# Notice of Allowability

10/780,171

Alexander Sofocleous

LIN ET AL.

FIG. 1A  
(PRIOR ART)

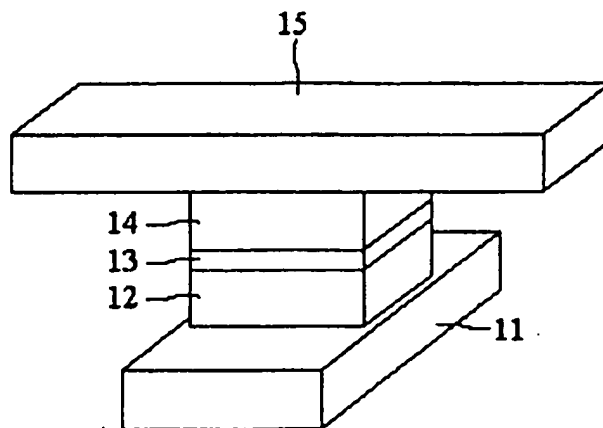
5. The proposed drawings corrections (Fig. 1A, 1B, 1C, 2A, 2B, and 3) received on January 30, 2006 are approved by Examiner.

APPROVED  
2-8-2006  
AGS
